Documentation of Public Meeting

Project Limits
Wurzbach Parkway from Lockhill-Selma Road to NW Military Highway

Open House Comment and Response Matrix
Wurzbach Parkway from Lockhill-Selma Road to NW Military, Bexar County CSJ: 1502-03-003
Open House Held February 28, 2017 at Oak Meadow Elementary School

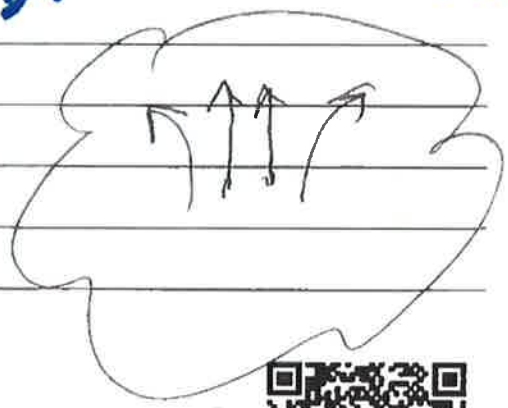
COMMENTS: ALLOW ONE OR TWO LANES EAST BOUND & WEST BOUND ON WURZBACH PKWY (THAT TRAVEL ~~UNDER~~ ACROSS NW MLTY).

TRADITIONAL INTERSECTION

Commenter Number	Commenter Name	Date Received	Source	Comment Topic	Response
59	Navin Bhatia	2/28/17	Comment Card	Allow one or two lanes eastbound and westbound on Wurzbach Parkway that travel across NW Military. Traditional Intersection.	Please see response to comment #7.
60	Anonymous	2/28/17	Comment Card	Please do not improve the parkway! Leave it as-is and instead spend the $30 million on adding a lane to 1604. We are tired of all the increased traffic that the parkway brings in; let these drivers go back to 1604 and/or 410.	The proposed project is needed to reduce traffic congestion and improve safety on Wurzbach Parkway and at project intersections.
61	Jesus Gallegos	2/28/17	Comment Card	I live in a home on Alon Estates that backs up to Wurzbach Parkway. Is there anything that can be done to mitigate the traffic noise coming into the neighborhood? I am hopeful something could be done, given advancements in construction materials, design and technology. Thanks.	Please see response to comment #38a.
